RE: Dowker Street – Planning responses

We acknowledge receipt of the planning comments related to the proposals and would look to respond as below:

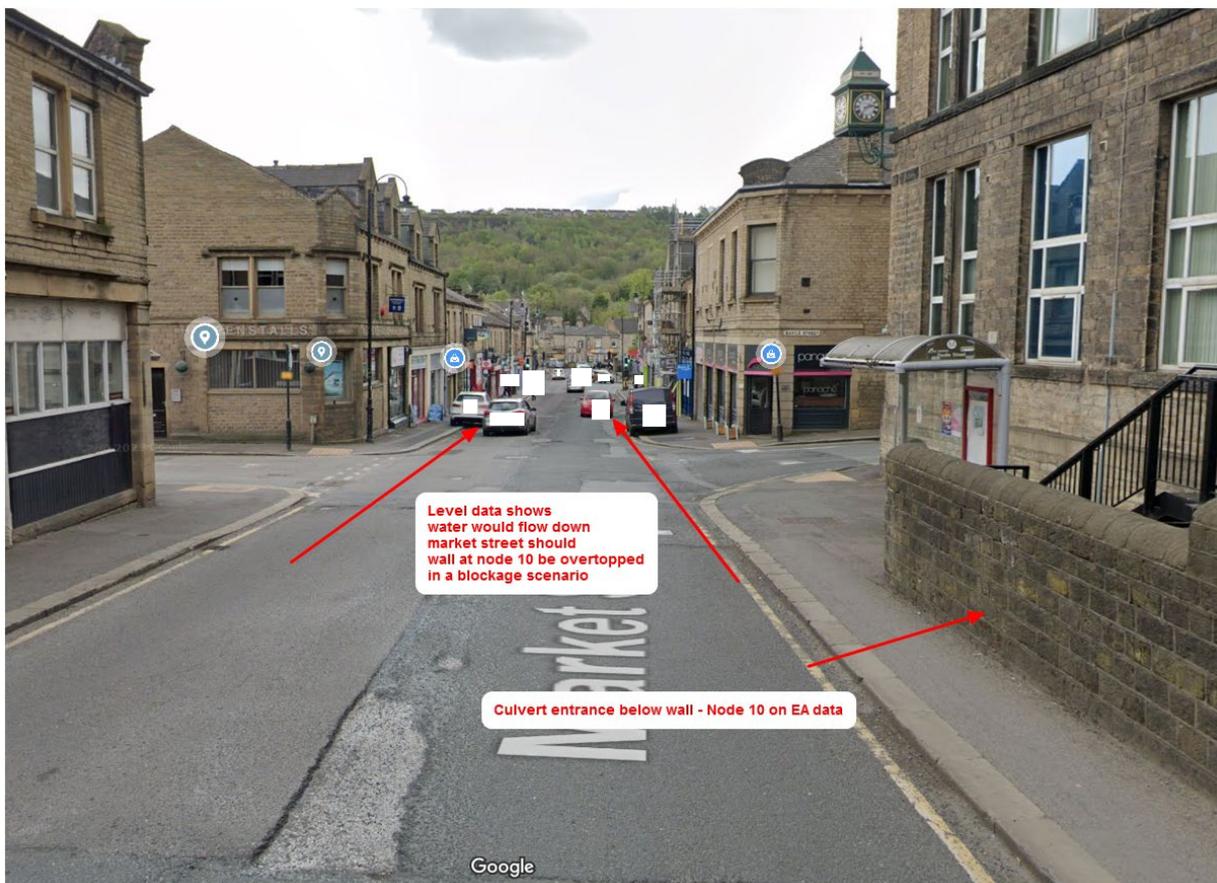
Objection 1 relates to the positioning of units within the culvert.

Layer Surveys have been out to site to inspect and trace but were limited for full access due to high flows in the culvert.

The drawing provided by them in Dec 23 shows their view on the route of the culvert based on MH lifts on site and chasing outfalls - particularly on the south side. Without man entry it is difficult to provide a condition survey and fully fixed line. The survey company are providing a new timeframe for a man entry survey that will be dependent on slower flows within the culvert.

We are not looking to build over the new culvert - just the access road - the culvert in this area will be suitably protected with a concrete cover slab to ensure the structural integrity. (note there were previously access roads and buildings built over the culvert in this position so any development works in this location would be less surcharge than the previous condition.
